Project	IEEE 802.16 Broadband Wireless Access Working Group < http://ieee802.org/16 >	
Title	Secondary Management Connection Transport	
Date Submitted	2007-01-11	
Source(s)	Peretz Feder – ALU Phil Barber - Huawei	pfeder@alcatel-lucent.com , pbarber@huawei.com
Re:		
Abstract	Fixes to section 14.2.3	
Purpose	Adoption, Replacing IP signaling with simple payload	
Notice	This document has been prepared to assist IEEE 802.16. It is offered as a basis for discussion and is not binding on the contributing individual(s) or organization(s). The material in this document is subject to change in form and content after further study. The contributor(s) reserve(s) the right to add, amend or withdraw material contained herein.	
Release	The contributor grants a free, irrevocable license to the IEEE to incorporate material contained in this contribution, and any modifications thereof, in the creation of an IEEE Standards publication; to copyright in the IEEE’s name any IEEE Standards publication even though it may include portions of this contribution; and at the IEEE’s sole discretion to permit others to reproduce in whole or in part the resulting IEEE Standards publication. The contributor also a

15 **Figure 477—SMC IP address signaling transport and notification**

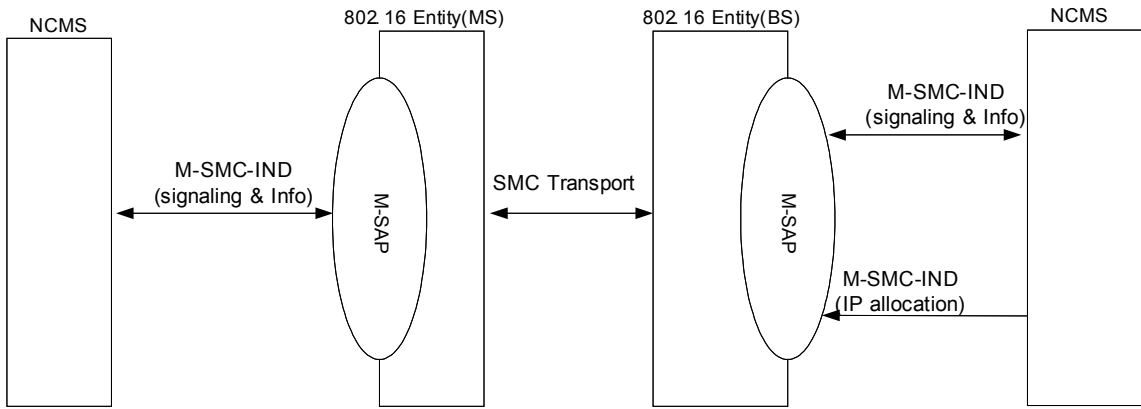
2
3 Correct section 14.2.3 “IP management with secondary management
4 connection”. Replace DHCP/MIP and IP address signaling with a generic
5 payload. Payload may carry IP signaling but no need to be shown in the spec.
6

8 This primitive provides transport of IP address signaling and allocation information between the NCMS and an
9 802.16 entity. This primitive is provided when the IP connection is managed by the secondary management
10 connection. It is available for both IPv4 and IP.
